### APPEAL SUMMARY

**Status:** Decision Rendered - Reconsideration of ID 20216

<b>Appeal ID:</b> 20501	<b>Project Address:</b> 151 SW 1st Ave
<b>Hearing Date:</b> 6/12/19	<b>Appellant Name:</b> Milena Di Tomaso
<b>Case No.:</b> B-009	<b>Appellant Phone:</b> 5038632425
<b>Appeal Type:</b> Building	<b>Plans Examiner/Inspector:</b> John Cooley
<b>Project Type:</b> commercial	<b>Stories:</b> 5 <b>Occupancy:</b> B, M ,S <b>Construction Type:</b> 3-A
<b>Building/Business Name:</b> PAE Living Building	<b>Fire Sprinklers:</b> Yes - Throughout
<b>Appeal Involves:</b> Erection of a new structure	<b>LUR or Permit Application No.:</b> 19-142823-LU
<b>Plan Submitted Option:</b> pdf [File 1]	<b>Proposed use:</b> Office, Retail

1 ELEVATION, EXTERIOR ENLARGED- WEST  
AP-1.6 1/2" = 1'-0"

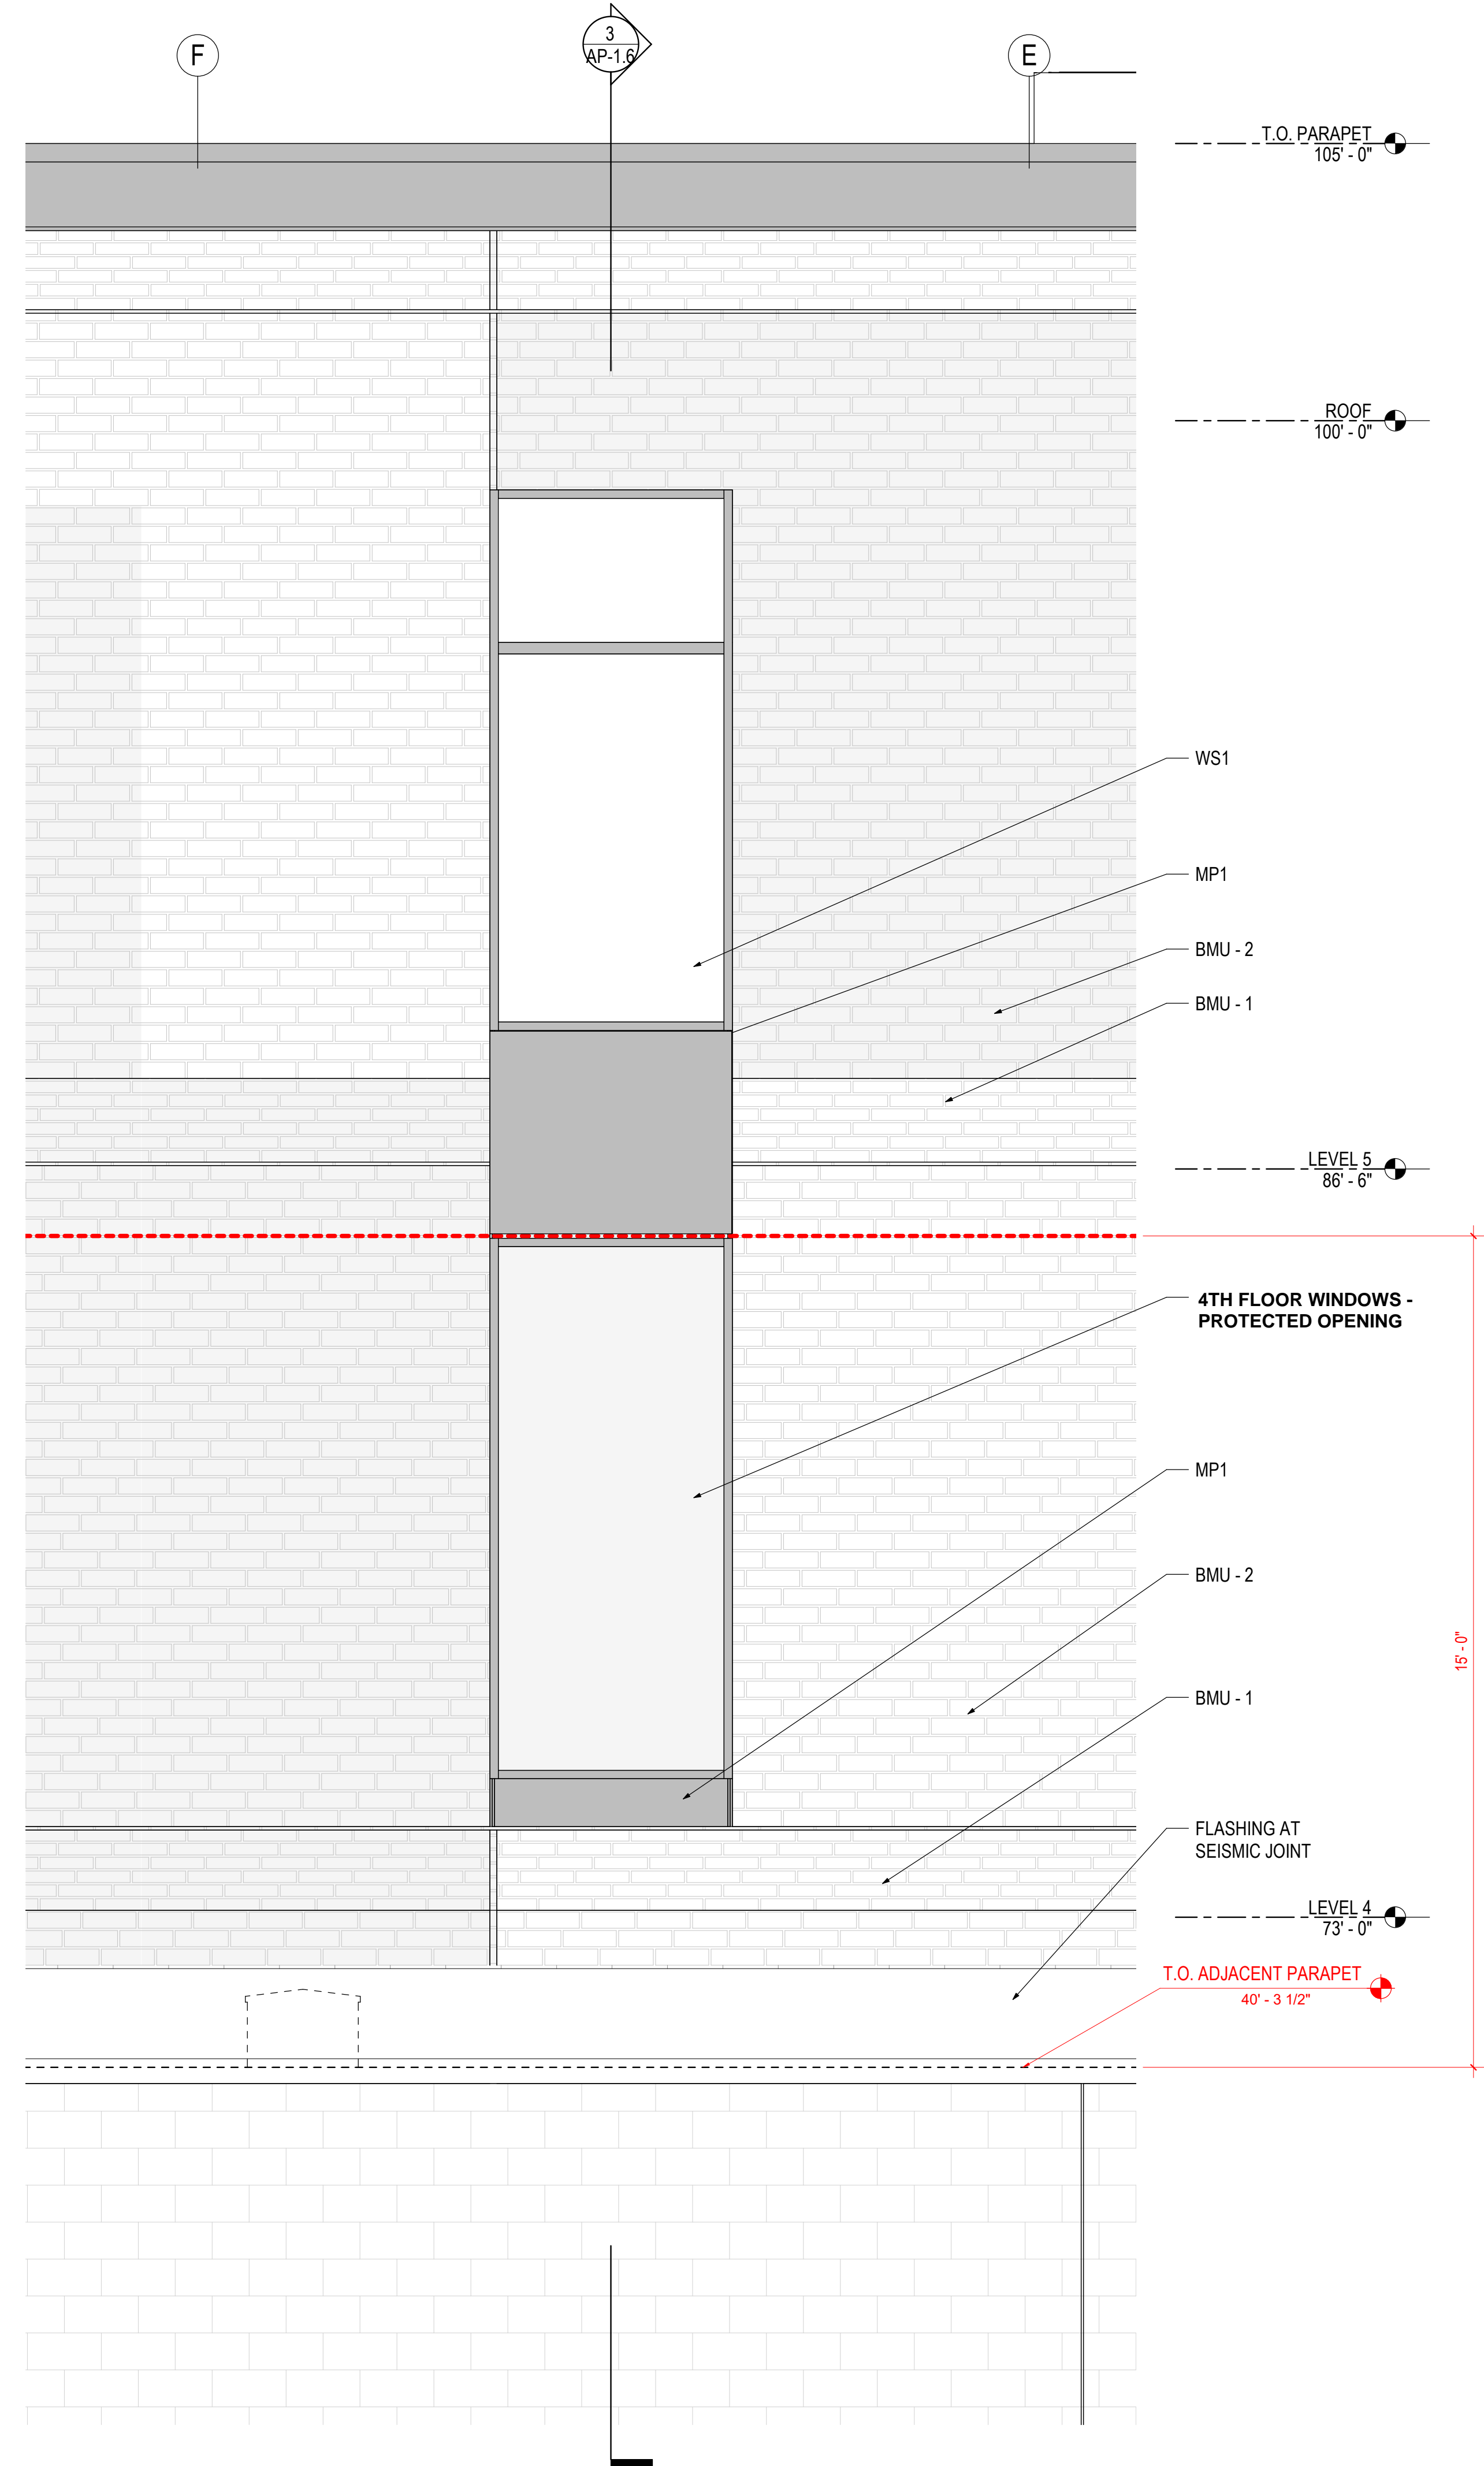
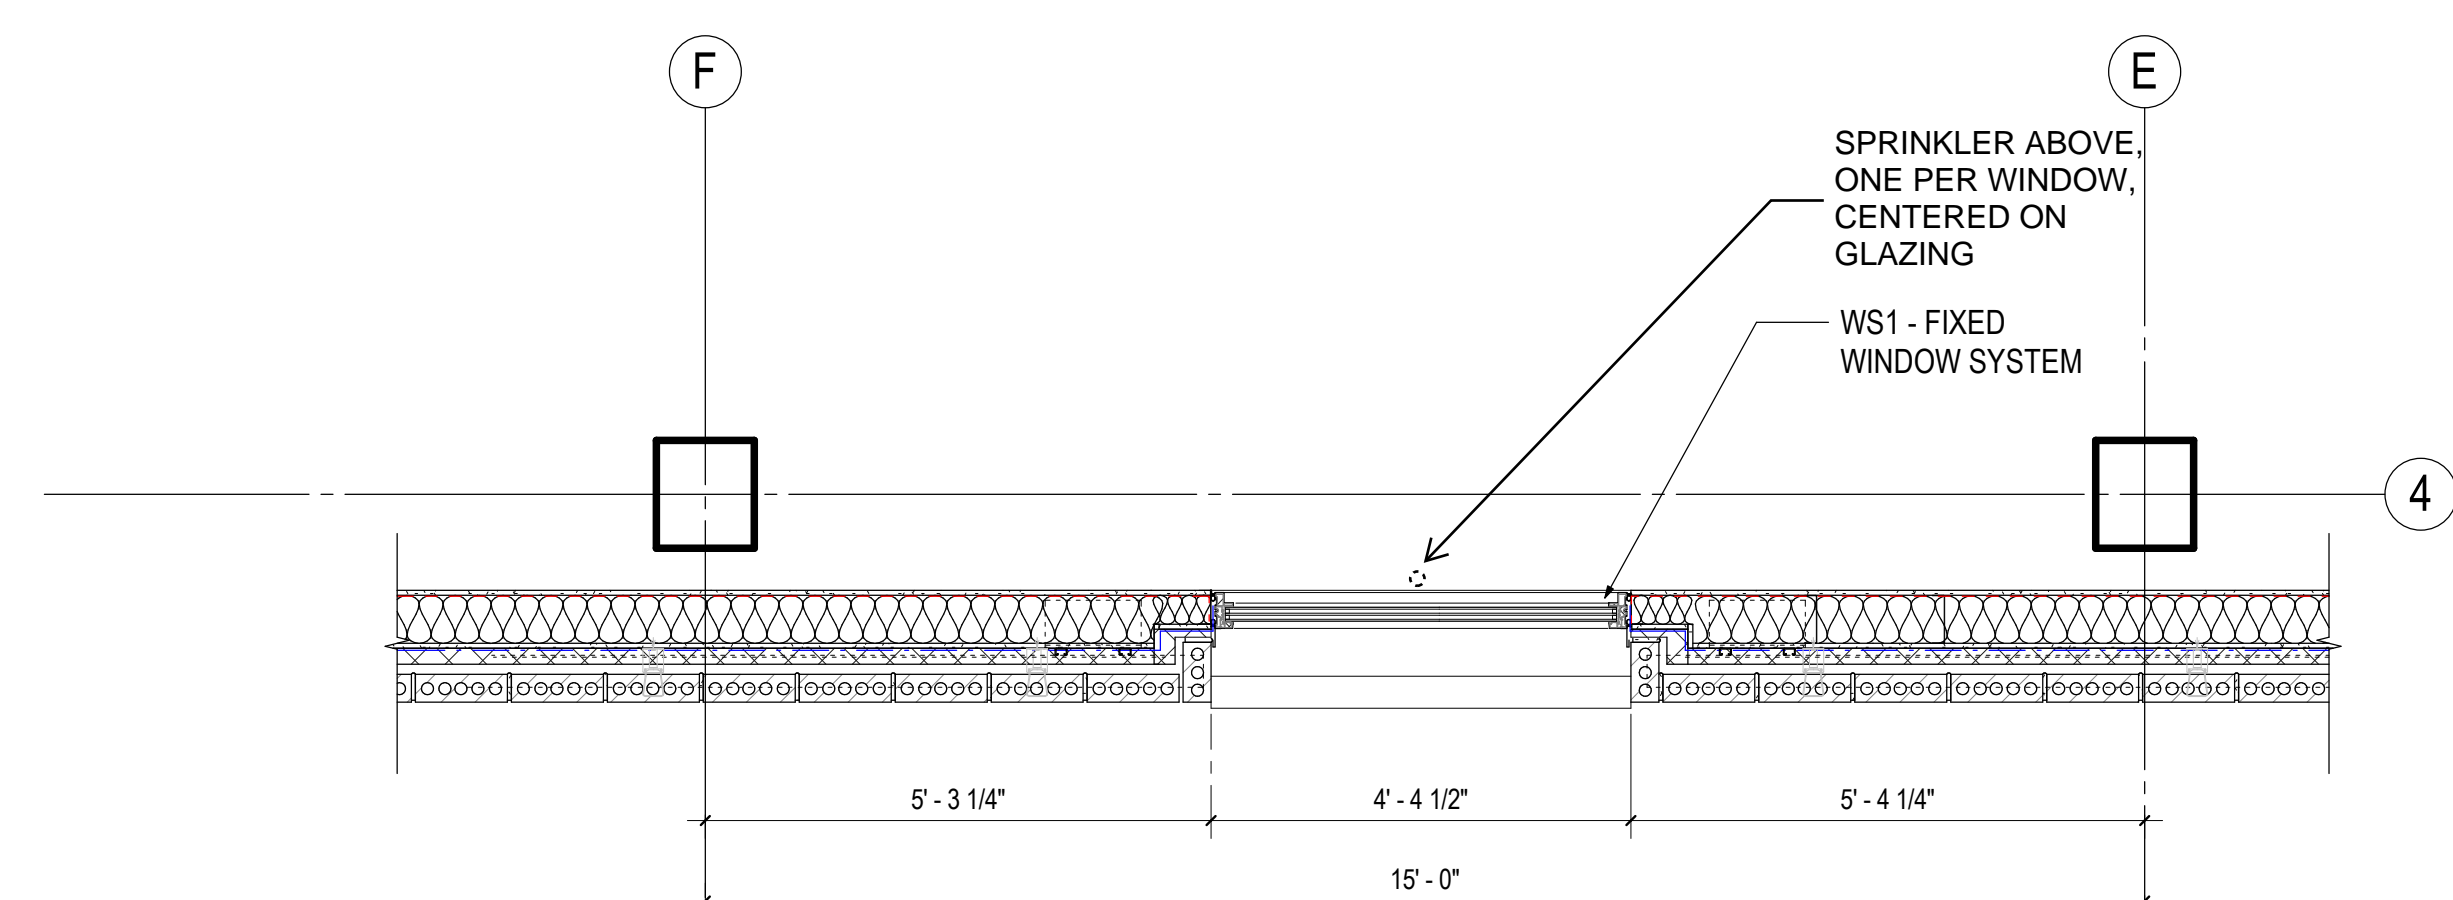
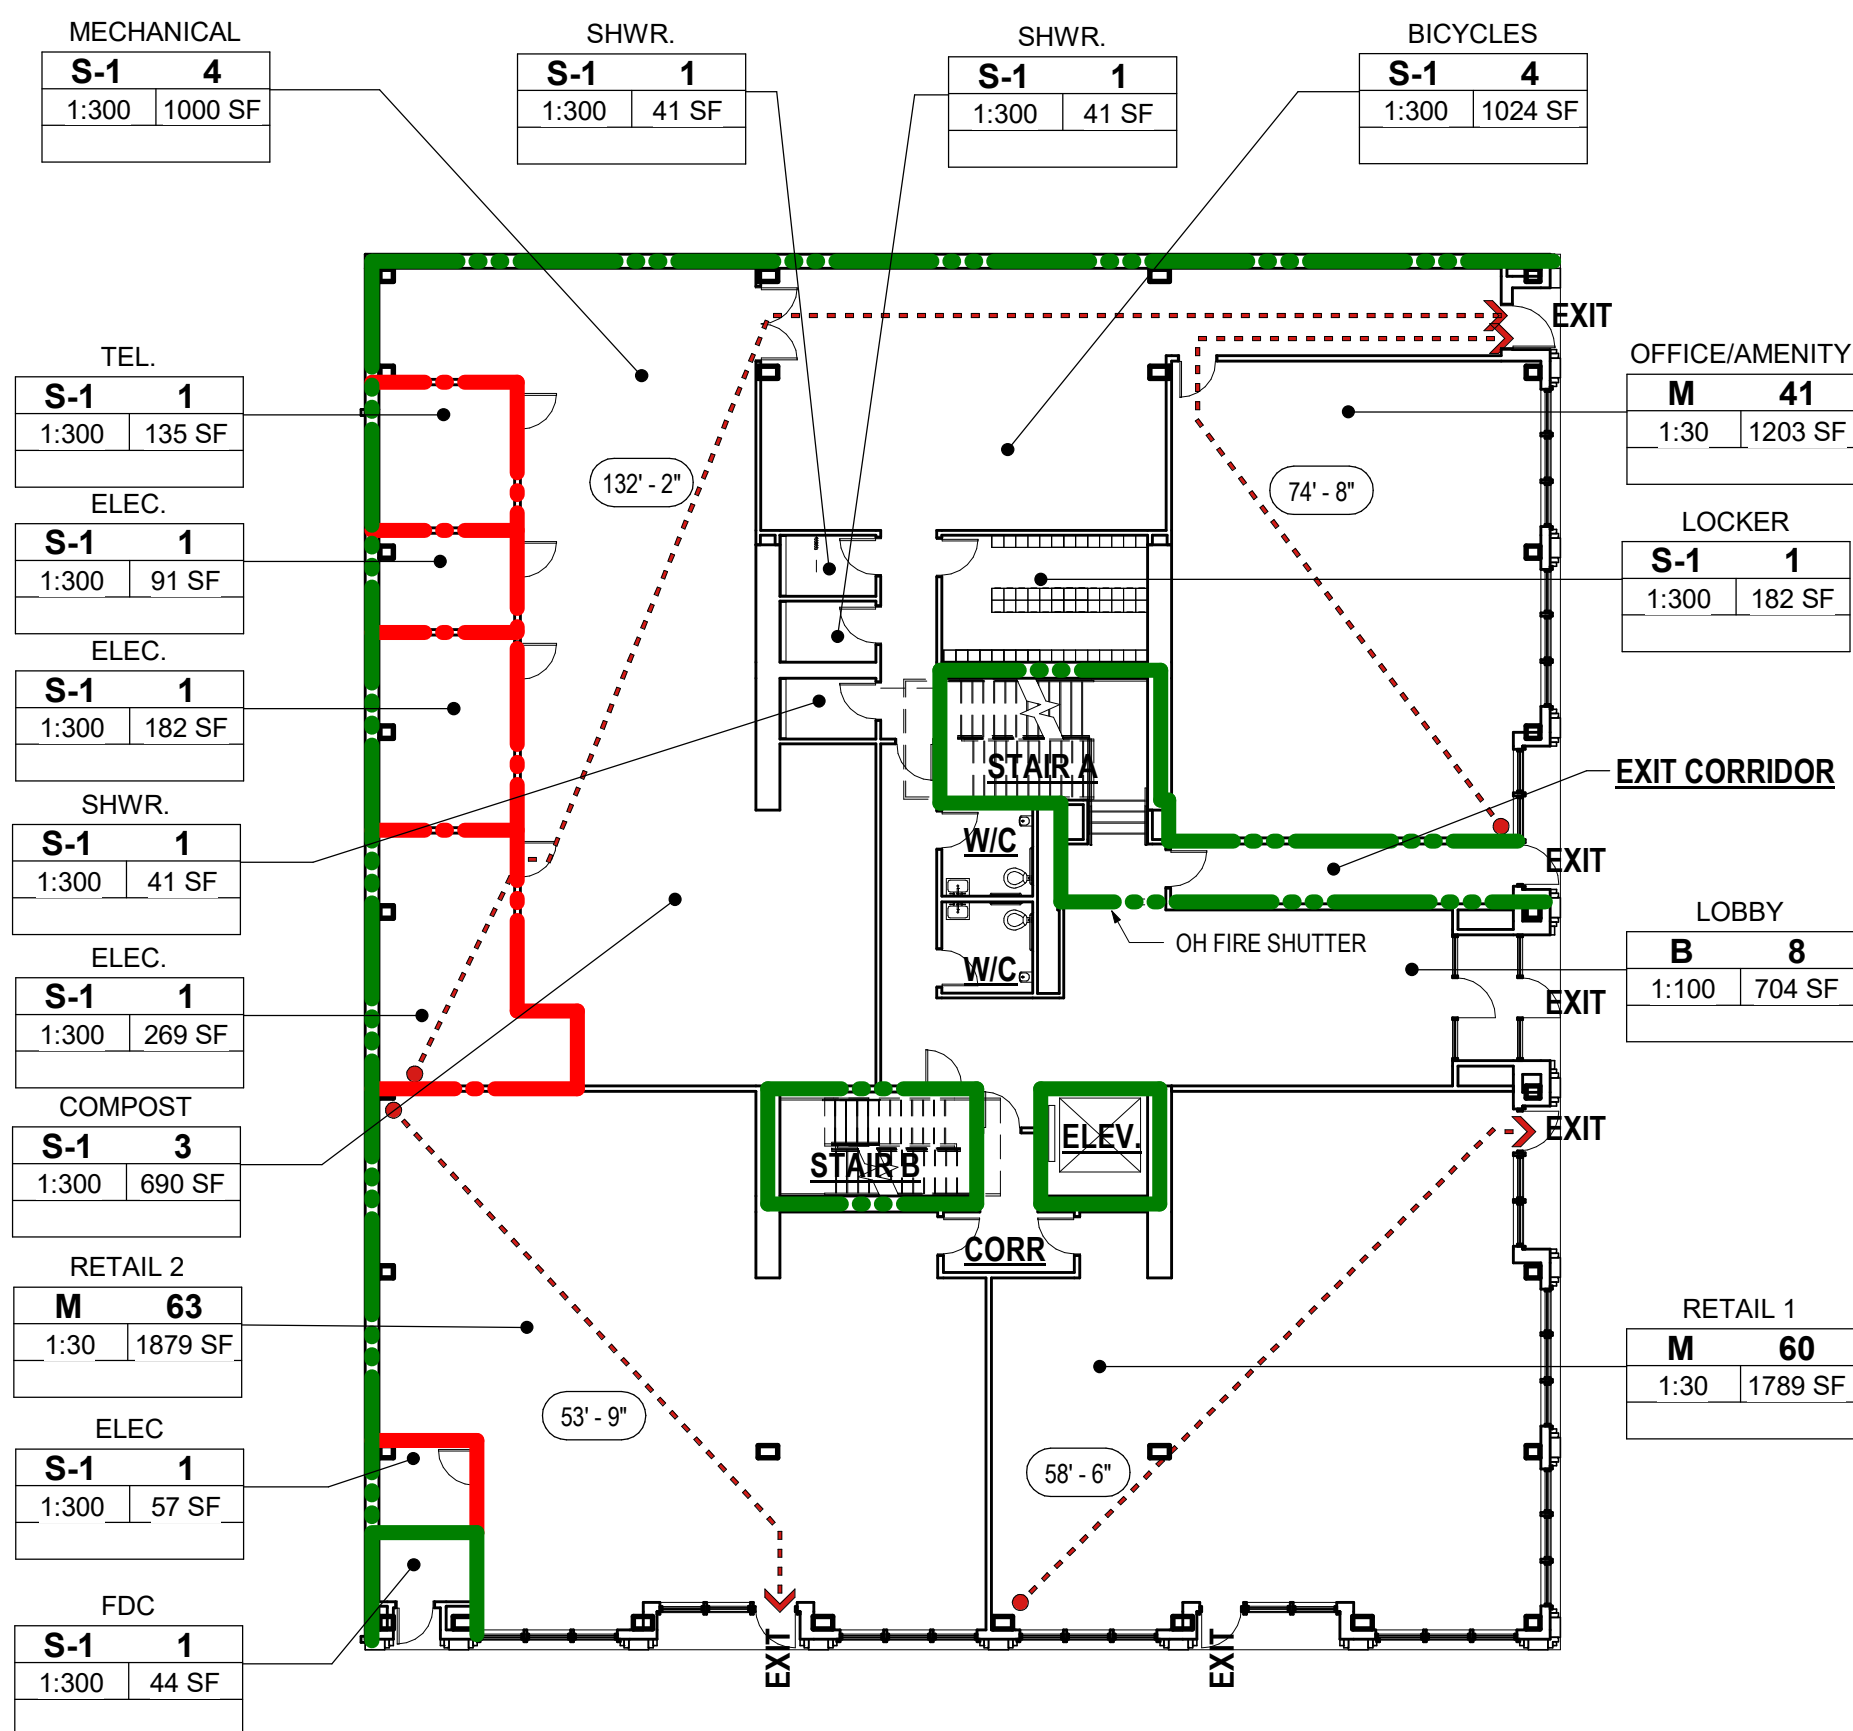
On the west elevation a total of twelve (12) glazed openings on the fourth and fifth stories are proposed to be built at the wall located 4" off the west property line. All windows on the 4th floor are within the 15'-0" vertical dimension from the rooftop of the existing adjacent building to the west. All the openings are proposed to be fixed non-operable windows, and no horizontal mullions exist.

Per 705.8.6.2, the west window openings are within the 15' dimension from the adjacent roof and will require a 45 min protective rating. We are proposing to provide a sprinkler on the interior face at the head of each window spaced a minimum of 6" and maximum of 12" from face of glazing. The windows are 4'-4" in width and will each have one sprinkler head centered on the window.

All proposed window openings on the 4th floor west elevation that are within the 15' dimension from the adjacent roof will be non-operable, they will have no horizontal mullions and will be provided with a sprinkler on the interior side at the head of each window spaced a minimum of 6" and maximum of 12" from face of glazing. The windows are 4'-4" in width and will each have one sprinkler head centered on the window. This will meet the 3/4 hour rating which provides equal protection as required by the code.

**2. Type 13 water curtain sprinkler protection at non-fire rated openings in buildings with vertical exposure on separate lots:** Granted provided windows are non-operable and sprinklers are spaced not more than 6 feet apart and placed a minimum of 6 inches and a maximum of 12 inches from the opening (s) and a maximum of 12 inches below the ceiling. Sprinklers are to be installed on the occupied side of the openings. A separate permit from the Fire Marshal's Office is required.
